# OFFICIAL PAPERS

## CONSTRUCTION OF THE MADRAS HARBOUR.

A. T. MACKENZIE, M.INST.C.E.,

*Local Consulting Engineer to the Madras Harbour Trust.*

## PROPOSED WORKS OF RE-CONSTRUCTION.

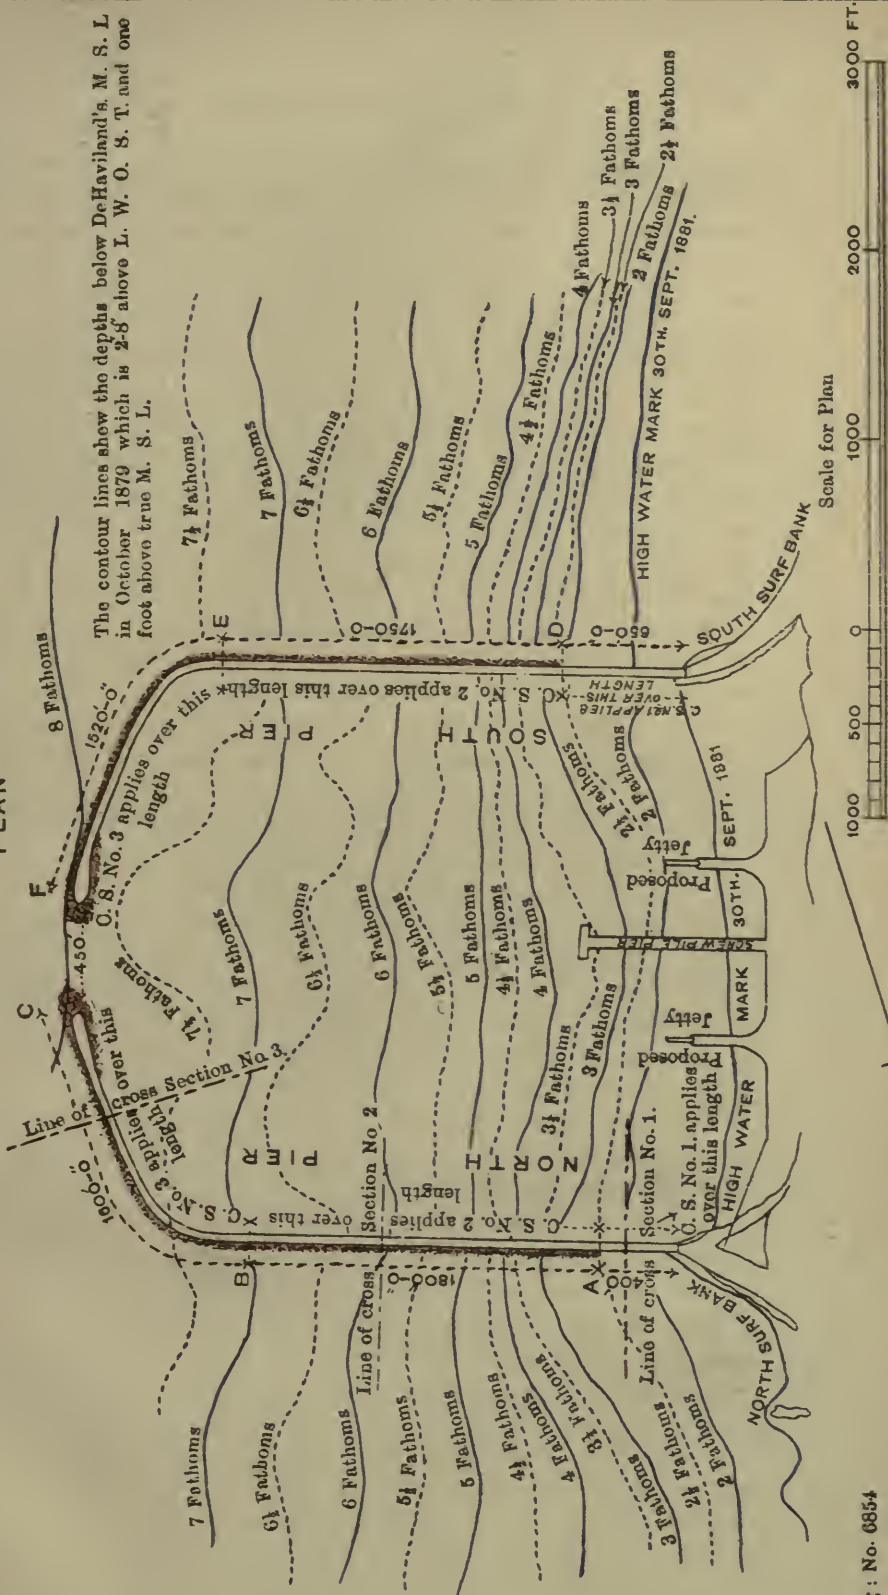
“For the landward portion of the piers, the works we recommend to be undertaken (shown on Cross-section No. 1), consist of cramping each pair of blocks in the upper course, and the addition of a mass of concrete carried up to 12 feet above high-water spring tides, the level to which we consider it necessary to raise the piers throughout their entire length. This mass of

### CROSS SECTION NO. 2.

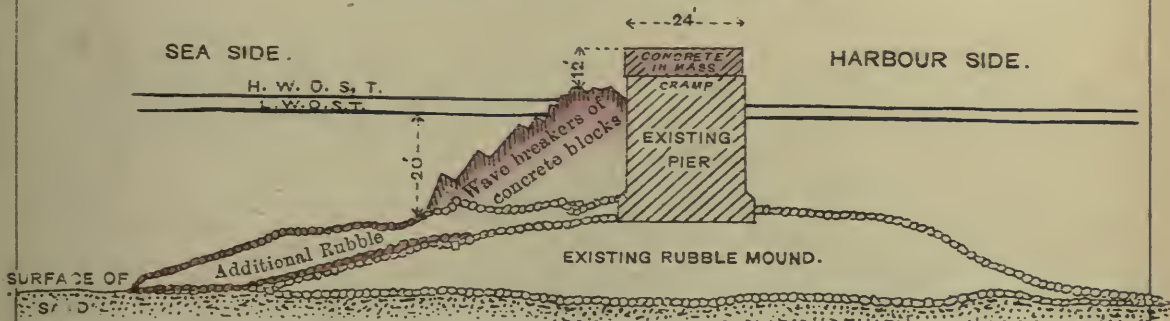
"For the next length of the piers, extending to the elbows, in addition to the cramping and the top mass of concrete, a wave-breaker, shown on Cross-section No. 2, of random concrete blocks, should be added on the seaward face, which will render it necessary to widen the rubble mounds. The concrete blocks for the wave-breakers should nowhere be less in weight than twenty tons.

## CROSS SECTION NO. 4.

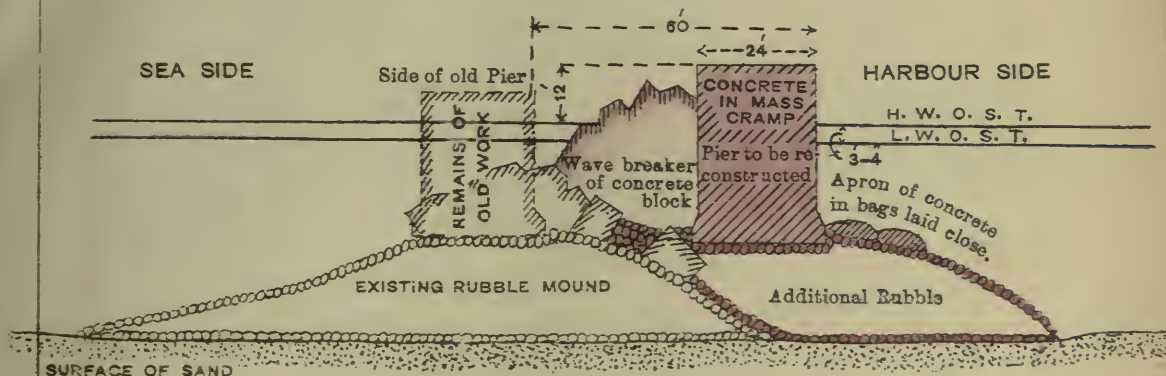
"A more certain plan of procedure for the reconstruction of these outer lengths of the piers would be to move them into the Harbour to the extent of about 60 feet, so that the new walls may clear the fallen blocks of the old structure, adopting the design shown on Cross-section No. 4, and this would involve a somewhat less expenditure than building on the original foundations. But it would shorten the Harbour—already very short—to the extent of about 60 feet; and also it would be undesirable if it could be avoided to build on a new foundation of unconsolidated rubble instead of taking advantage of the old consolidated mounds.

"The plan, therefore, we recommend for the reconstruction of the outer lengths from B on the north pier and E on the south pier, to the seaward ends, is in the first instance to endeavour to continue the walls on the old foundations, as shown on Cross-section No. 3. Before the elbows of the piers are finished it will be seen whether this plan can be successfully carried out; if so, the system should, we think, be followed. If not, the piers should be brought in to the extent of about 60 feet, following the design shown on Cross-section No. 4.

## CROSS SECTION NO. 5.

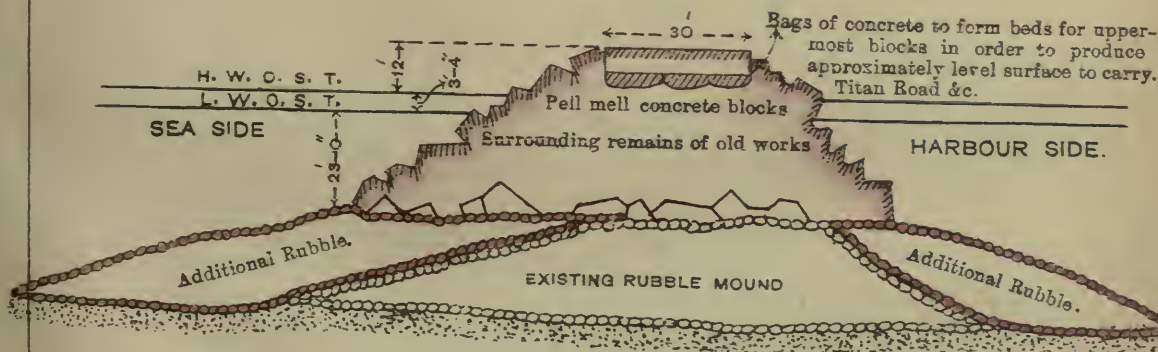
CROSS-SECTION No. 5 shows a method of reconstruction by adopting random concrete blocks.

"In considering the matters now referred to us, we have had interviews with Mr. Parkes, who has explained to us his views. He sees some difficulty, as we did, in carrying out the system shown on cross section No. 5, and seems farther to be of opinion that he should prefer to adopt cross sections 1, 2, and 4. With regard to this question, we think you may be guided by Mr. Parkes with the clear understanding, so far as we are concerned, that nothing is done to weaken any of the works recommended by us, whichever of the methods be adopted, and that the piers be not built to a lower level than we have already advised.

PROPOSALS FOR RESTORATION BY MADRAS SPECIAL COMMITTEE

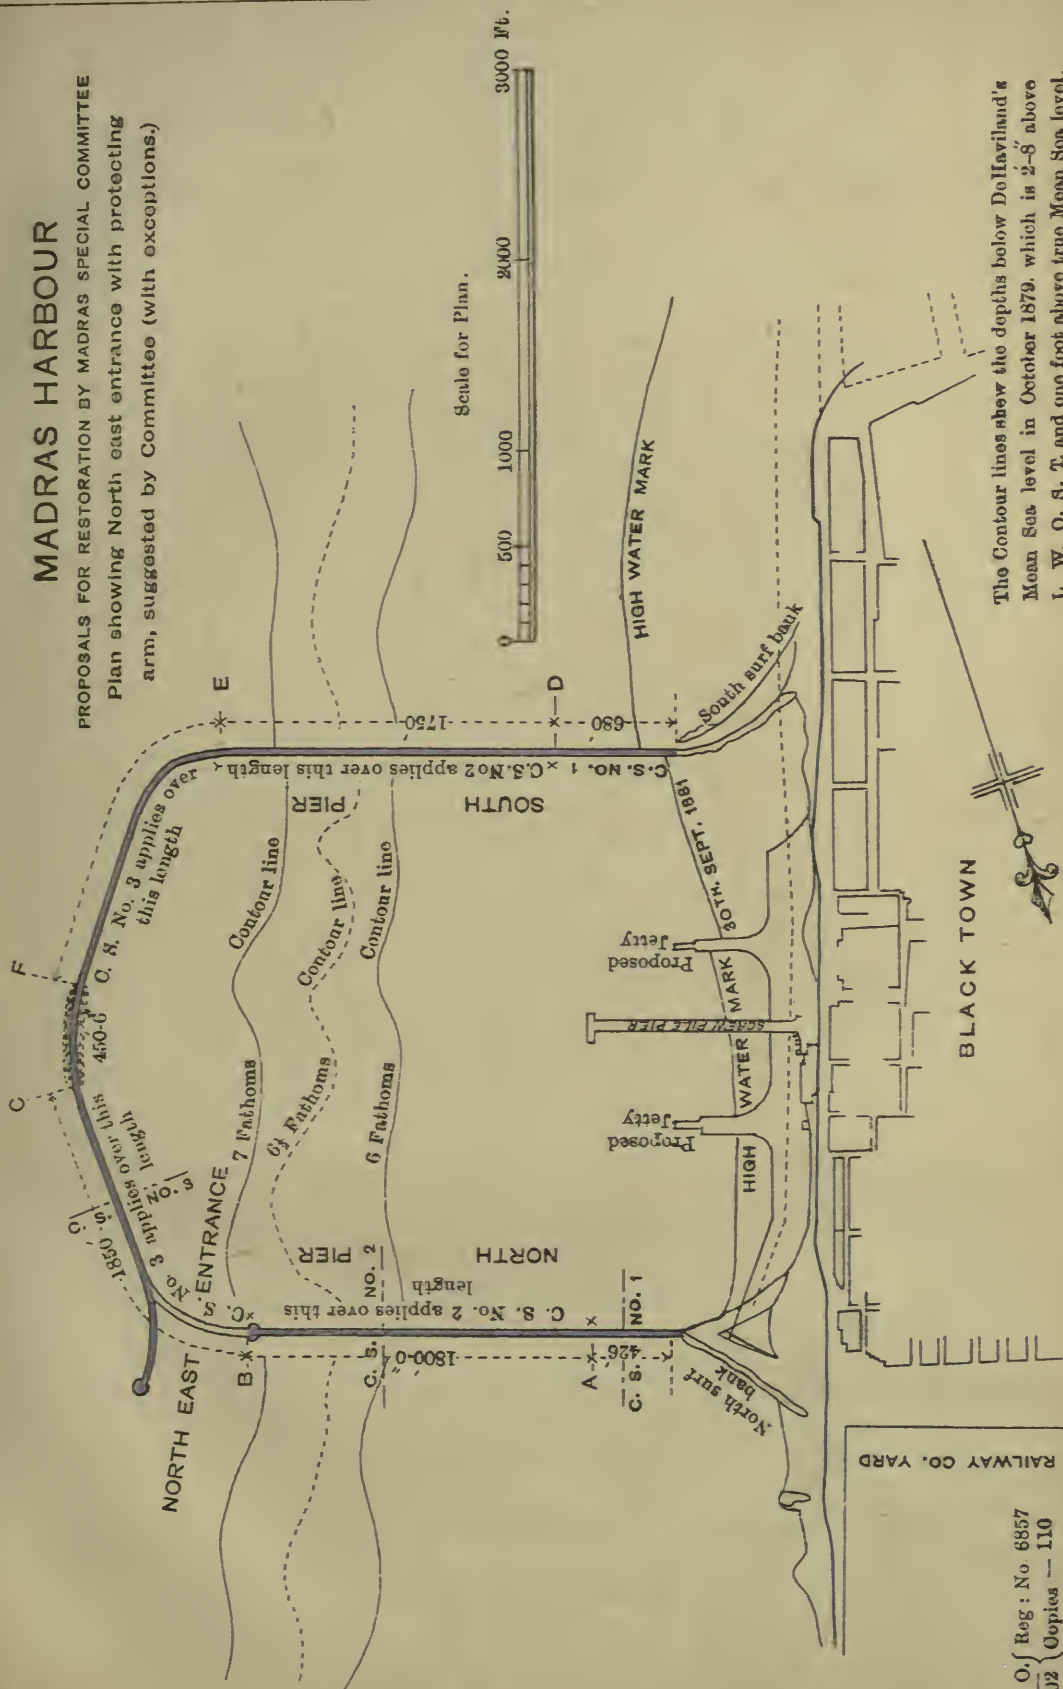
"I presume that the nautical authorities on the Madras Committee have satisfied themselves as to the practicability of a ship entering the harbour by such an entrance in stormy weather; but I think it would be desirable to refer this question to the highest nautical authorities in India.

"Assuming, however, the feasibility of such an entrance, I am of opinion that the form of breakwater proposed for covering this entrance requires some modification. In its proposed form it is open to serious objections, involving, as it does, a re-entering curve which would never stand the blow of a cyclonic wave.

"The change suggested by the Madras Committee requiring the gravest consideration is their proposal to make a new entrance to the harbour at its north-eastern elbow and to stop up the existing entrance. Their object in making this proposal is to secure stiller water inside the harbour, a thing desirable in itself if attainable with due regard to other considerations, and they state that the work remodelled in this and in other respects as they recommend will cost much the same as the works advised by us in our report of the 23rd January 1883.

"The Madras Committee arrive at this conclusion of equality of cost by leaving out from their project the wave-breaker on the south side and the concrete cap on both sides of the harbour, and appear to have assumed, though we are at a loss to know why, that we did not attach any very indispensably constructive value to this portion of our recommendation. They seem to have looked at our proposal to raise the piers by a concrete capping mainly as a question of waves spilling over them into the harbour, though the observation in our report was that raising the piers to the height we advised would add to the security of vessels within the harbour in rough weather, and would greatly strengthen the work.

Diagram No. 3 to accompany note by Mr. MOLESWORTH dated July 17th 1883.

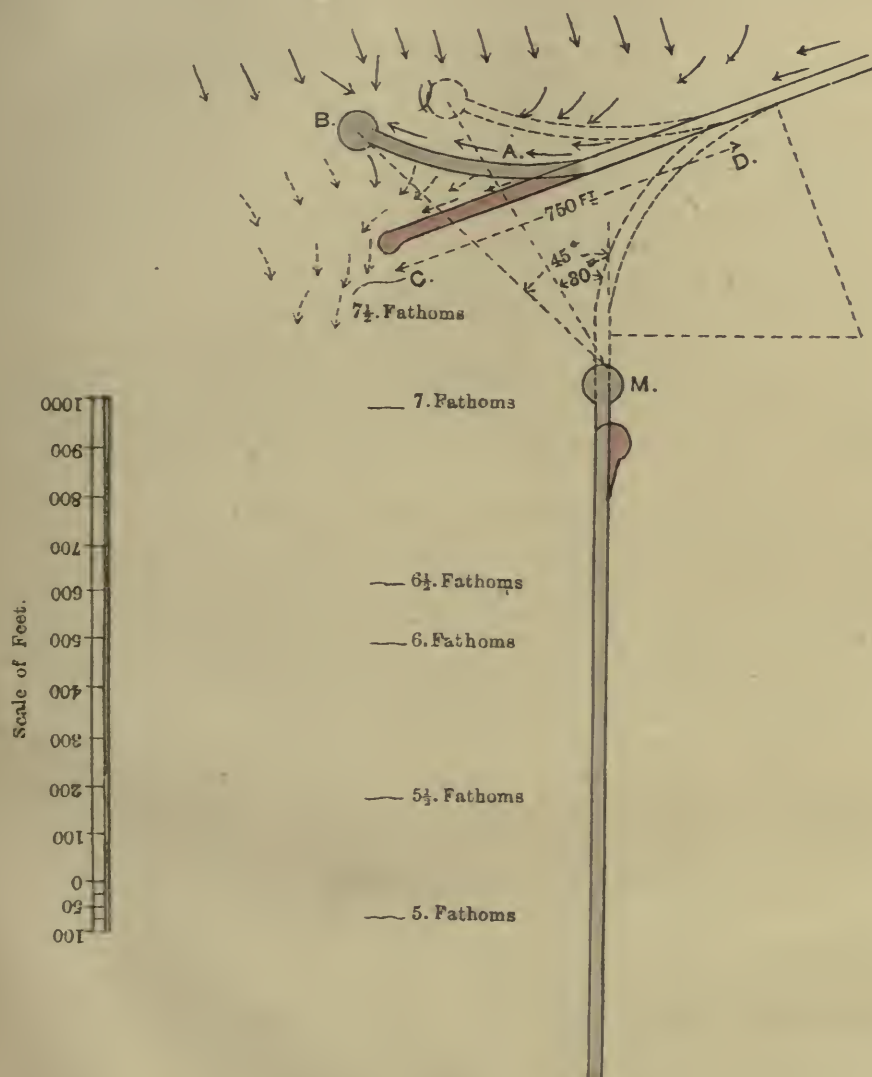
4th.—The re-entering curve proposed by the Madras Committee in the overlapping arm to the north-east elbow is open to serious objections, but I notice that Mr. Thorowgood, in his letter, dated January 31st, 1887, has submitted a sketch in which this is modified to meet the objection to a re-entering curve raised in my note of July 17th, 1883.

NOTE - The dotted lines shew the breakwater as proposed by the Madras Committee. The portions coloured black shew the increased length suggested by Col. Trevor. The portions coloured red shew the modification proposed by Mr. Molesworth.
